LAND COURT OF QUEENSLAND

SECOND AFFIDAVIT OF JOHN WILLIAM BRADLEY

MEMORANDUM

From: John Bradley, JBT Consulting
To: Peter Stokes, McCullough Robertson Lawyers
Subject: Adani Mining Pty Ltd v Land Services of Coast and Country Inc & Ors
Response to Expert Report of Dr John Webb
Date: 17 March 2014
Our reference: JBT01-049-004-Response to J Webb Expert Report.docx

Figure 2-1: Water Sample Sites – 2014 Data

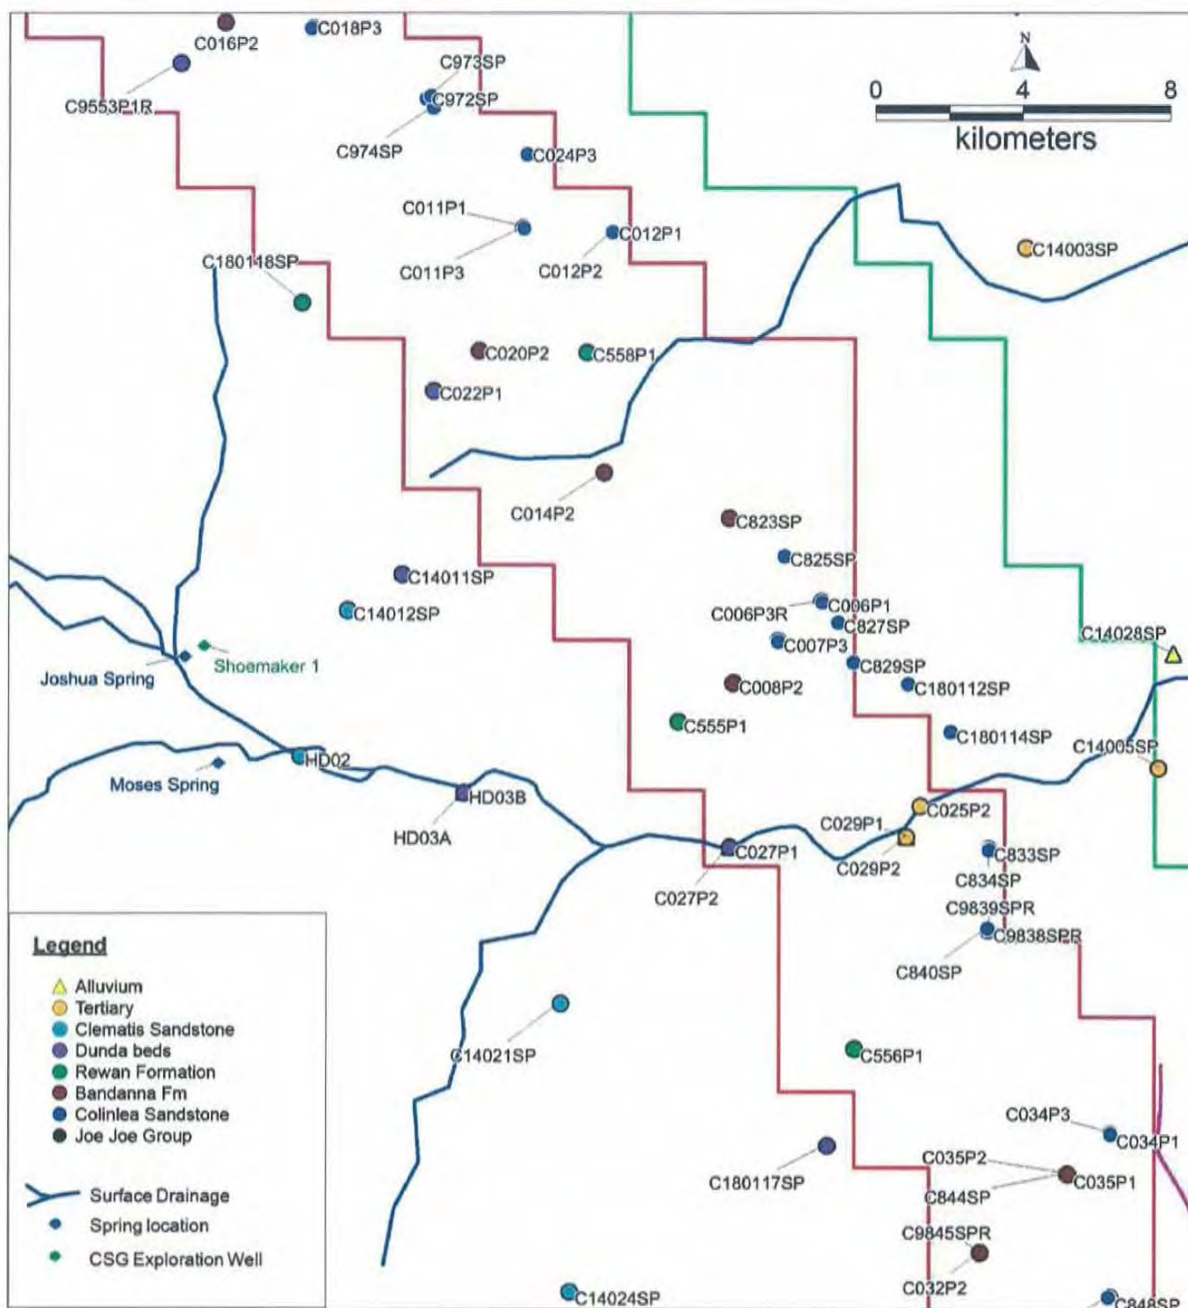
- (v) It is not certain which two bores Dr Webb is referring to when he states (paragraph 54 (e)) that *“Groundwater with a similar salinity to the springs occurs in the D seam in 2 bores to the east of the springs (50-60 mg/L Cl)”*, however the location of bores for which water quality samples were available for the 2014 year are shown on Figure 2-1 of this report. Based on the summary Cl data presented below in Table 2-2 it is concluded that there is no clear correlation between Cl from the Doongmabulla Spring Complex (Joshua Spring) and any particular groundwater unit. Therefore Dr Webb’s assertion that Cl data can be used to support an interpretation that the Colinlea Sandstone is the source aquifer for the Doongmabulla Spring Complex is rejected.

Figure 3-1: Model layout showing phreatic surface for Steady-State Model 1

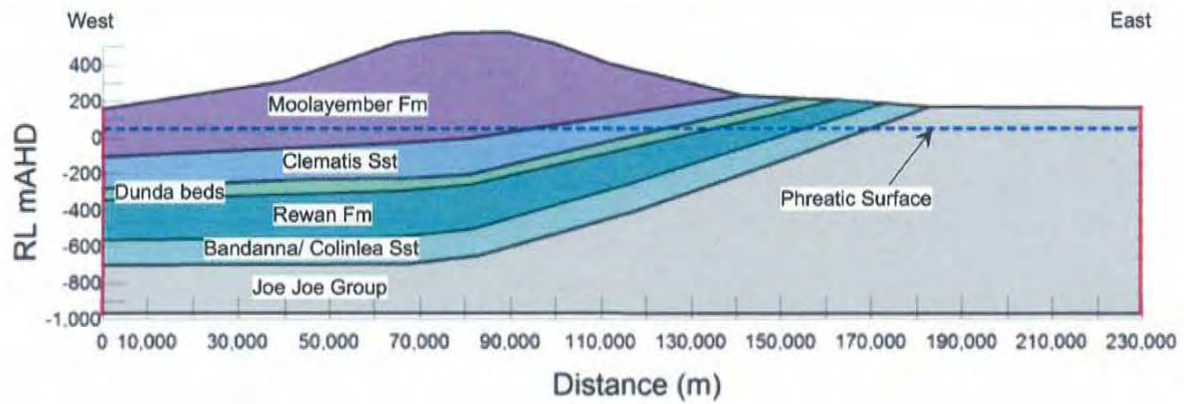
- (ii) The model shows the geology dipping from east to west at a similar dip to that observed for the strata observed at the location of the Carmichael Project, as shown in Figure 3-1 below. The vertical exaggeration of the model section is 40 x.

20. Output from the model is presented below in Figures 3-1 to 3-6. In summary:
- (i) Figure 3-1 shows the layout of Steady-State Model 1, which uses constant head nodes at the eastern and western edges of the model to create an initial flat phreatic surface;

Figure 3-2: Area of groundwater recharge and resulting phreatic surface for Steady-State Model 2

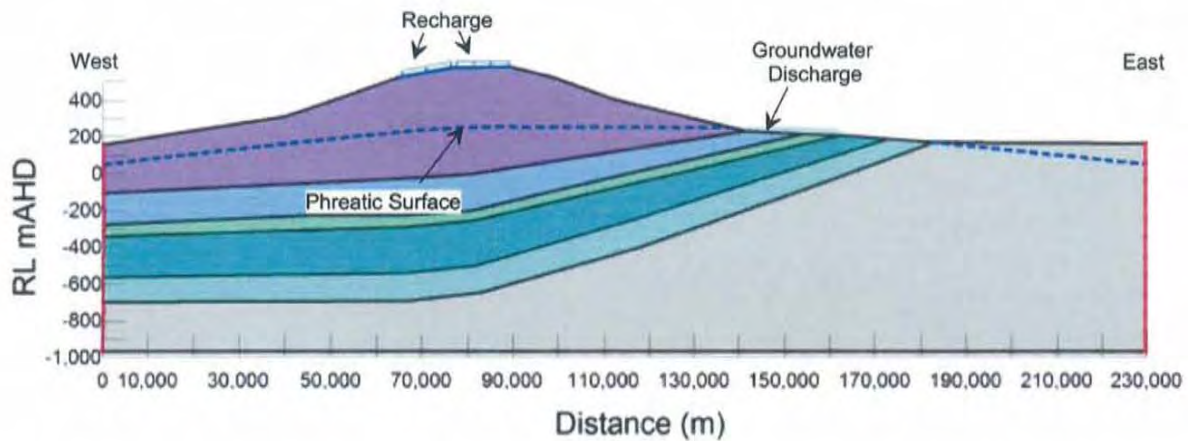
- (ii) Figure 3-2 shows the layout of Steady-State Model 2. This model utilised the same boundary conditions at the eastern and western edges of the model as were used for model 1, but included the application of recharge in the topographically elevated area, which is an exaggerated representation of the Great Dividing Range to the west of the Carmichael Project (i.e. the approximate location of the groundwater divide in the GHD model).

- (iii) Recharge applied to the topographically elevated region of the model has created a groundwater mound under the recharge area, which can be seen to be intersecting the ground surface to the east of the recharge area in the area where the Clematis Sandstone is outcropping in the model.

Figure 3-3: Detail from Steady-State Model 2 showing groundwater divide and flow vectors

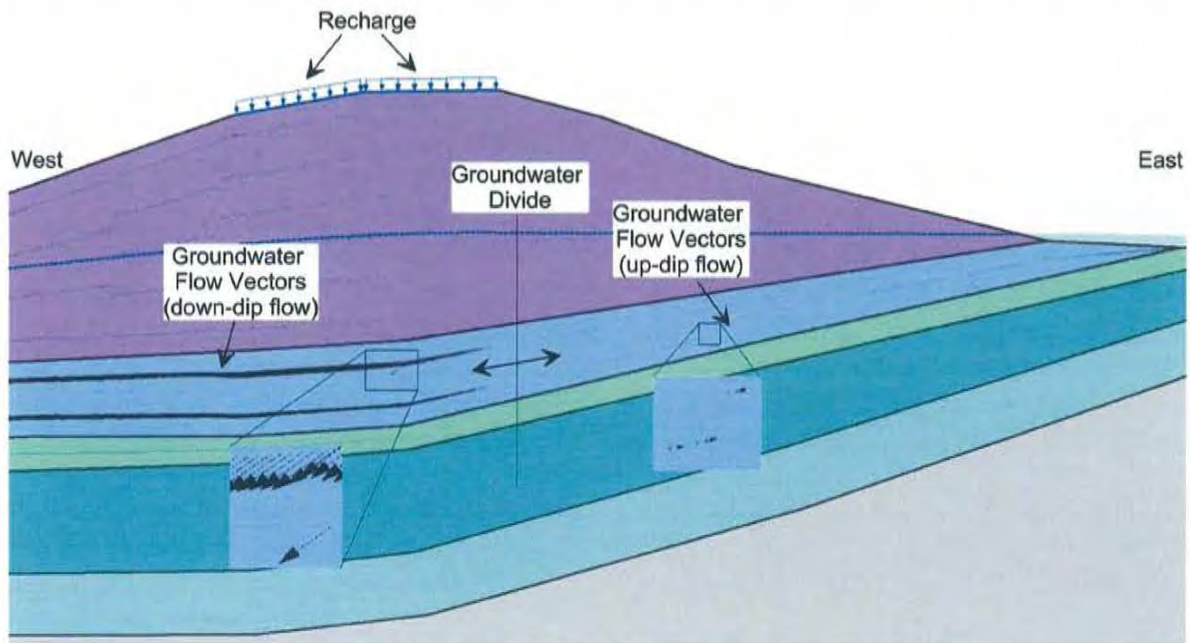
- (iv) Figure 3-3 shows detail from Steady State Model 2, with groundwater flow velocity vectors turned on in the model. Information from this figure is summarised as follows:

- b. Included on Figure 3-3 is the location of the groundwater divide, i.e. the region of the model where the overall direction of groundwater flow changes from west (down-dip) to east (up-dip)

- c. The groundwater flow vectors are largest in the direction of westward (i.e. down-dip) groundwater flow; however a component of easterly (up-dip) groundwater flow occurs as flow in this direction is controlled by groundwater pressure rather than the dip of the geology;

- d. Groundwater flow occurs principally within the Clematis Sandstone, which is the unit with the highest hydraulic conductivity in the model. Groundwater flow vectors are also visible within the Moolayember Formation and Dunda beds, however no flow vectors are shown in units below

Figure 3-4: Detail from Steady-State Model 2 showing groundwater discharge area

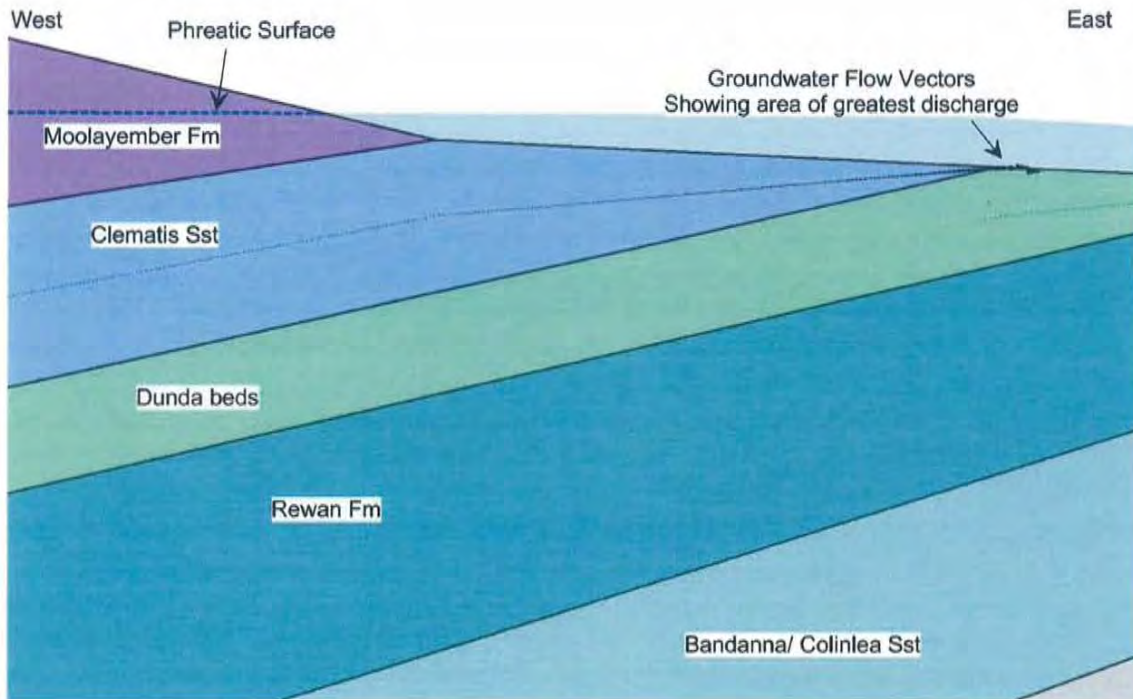
- (v) Figure 3-4 shows a blown-up area of Figure 3-3 in the area of the Clematis Sandstone outcrop. The greatest magnitude of groundwater flow (based on flow vectors) can be seen to be occurring from the boundary between the Clematis Sandstone and the underlying Dunda beds. This figure demonstrates the simplest and most likely explanation as to why the Doongmabulla Springs are occurring at the location that they are, with the reasoning summarised as follows:

- a. The groundwater mound beneath the recharge area does not develop symmetrically. In part this is due to the asymmetry of the recharge area with respect to the boundaries of the model (where the constant heads are located). However the major reason for the asymmetry is interpreted to be related to the presence of the low-permeability Rewan Formation close to surface, which "holds up" the groundwater mound to the east of the recharge area

- b. Groundwater discharge occurs from the model from the highest permeability unit (in this case the Clematis Sandstone) in the area where the aquifer pinches out against underlying lower permeability units

- c. This serves to demonstrate that groundwater flow to the springs can be derived from shallow groundwater units and that the springs in this case are occurring as rejected recharge springs - i.e. downward flow of recharge is prevented by the presence of the low-permeability Rewan Formation, with lateral groundwater flow then discharging to surface as springs in topographically low areas

Figure 3-5: Output from Steady-State Model 1 showing contours of Pressure Head

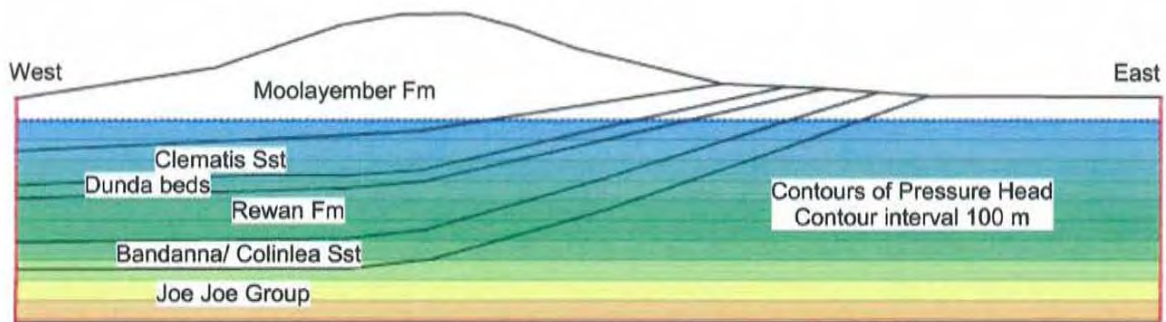
- (vi) Figure 3-5 shows contours of groundwater pressure head from Steady State Model 1. The zero pressure line is the phreatic surface (blue dotted line) with groundwater pressure increasing linearly with depth below the phreatic surface. The variable hydraulic conductivity of the different groundwater units is not perturbing (i.e. deflecting) the pressure contours as the groundwater model has been run to steady-state

Figure 3-6: Output from Steady-State Model 2 showing contours of Pressure Head

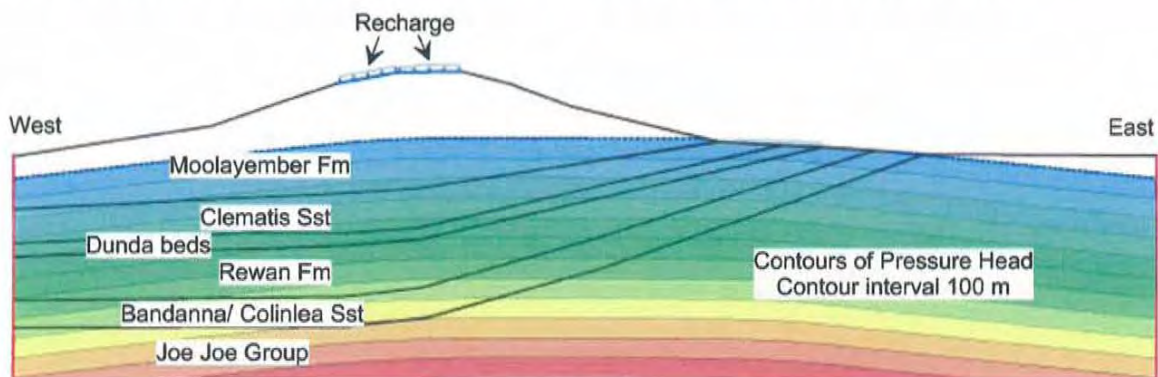
- (vii) Figure 3-6 shows contours of groundwater pressure head from Steady State Model 2 (incorporating groundwater recharge in the topographically elevated area of the model). This figure demonstrates the following:

- a. Groundwater pressure is elevated beneath the recharge area. This equates to the groundwater divide that occurs in the Colinlea Sandstone to the west of the proposed Carmichael mining area;

- b. Elevated groundwater pressures occur in all units underlying the recharge area, including the Rewan Formation and the underlying Bandanna Formation/ Colinlea Sandstone. This is because:

- iii. The high phreatic surface under the recharge area applies pressure to all underlying groundwater units, resulting in a higher pressure head being applied to all units. This would manifest (e.g. for the Colinlea Sandstone) as a higher groundwater level under the recharge area, with lower pressure beneath the groundwater discharge area (i.e. the springs) in the east. This is consistent with the groundwater contours shown as Figure 1 of

Figure 4-1: Location of Springs, Wells and Photo Locations from Dr Webb's Report with background of 1:250,000 scale geology

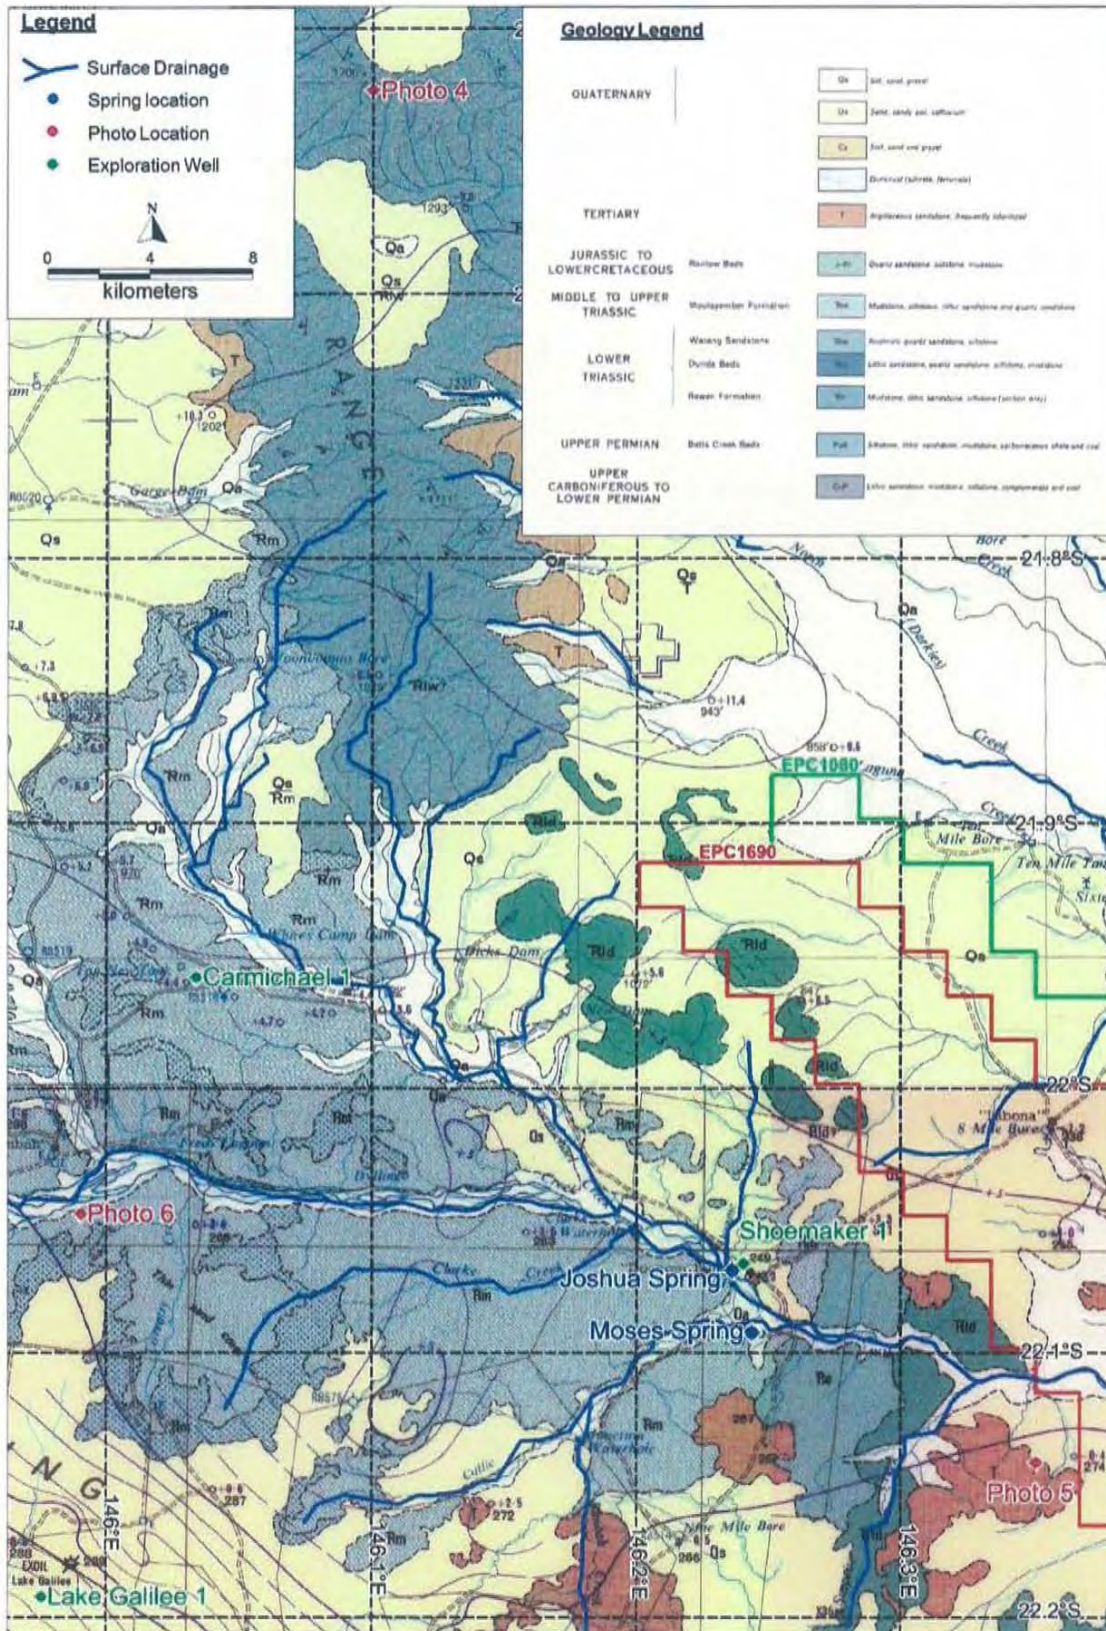
26. Dr Webb asserts in his discussion of Figures 10 (a to d) that a number of geological features are clearly evident from these figures. For example in the text accompanying Figure 10 (page 21 of Dr Webb's report) it is stated that 10a shows "*Radiometric image, showing pink area (Rewan Formation)*" and Figure 10b shows "*457 image, clearly showing Dunda Beds outcrop*". However the figures as presented are quite small and all figures are unlabelled. Therefore it is difficult to distinguish the features to which Dr Webb refers.

- (i) Figure 4-1, showing the location of features described above with a background of the published 1:250,000 geological maps of Galilee and Buchanan; and,

Figure 4-2: Location of Springs, Wells and Photo Locations from Dr Webb's Report with background Radiometrics Image

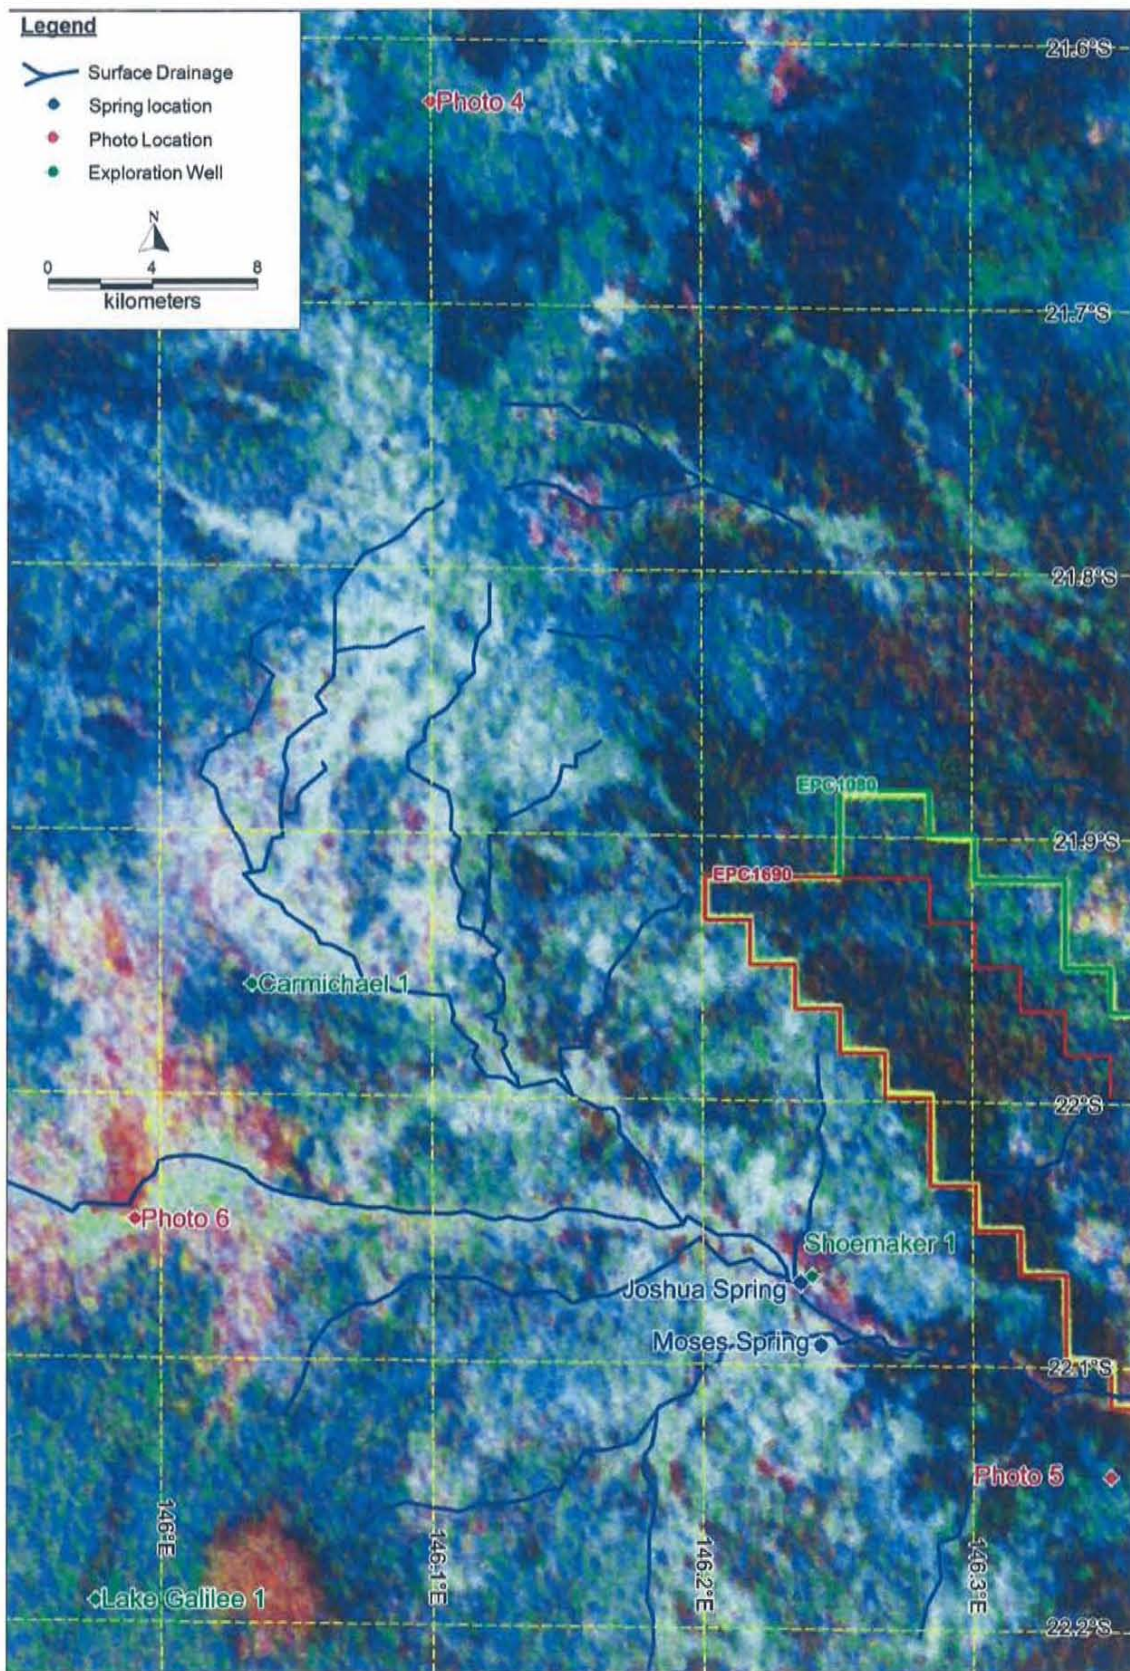
- (ii) Figure 4-2, showing the location of features described above with a background of the radiometrics image shown as Figure 10a of Dr Webb's report (based on a hard-copy of the radiometrics image which was provided to me by Dr Webb during our joint groundwater experts conclave of 22 December 2014).
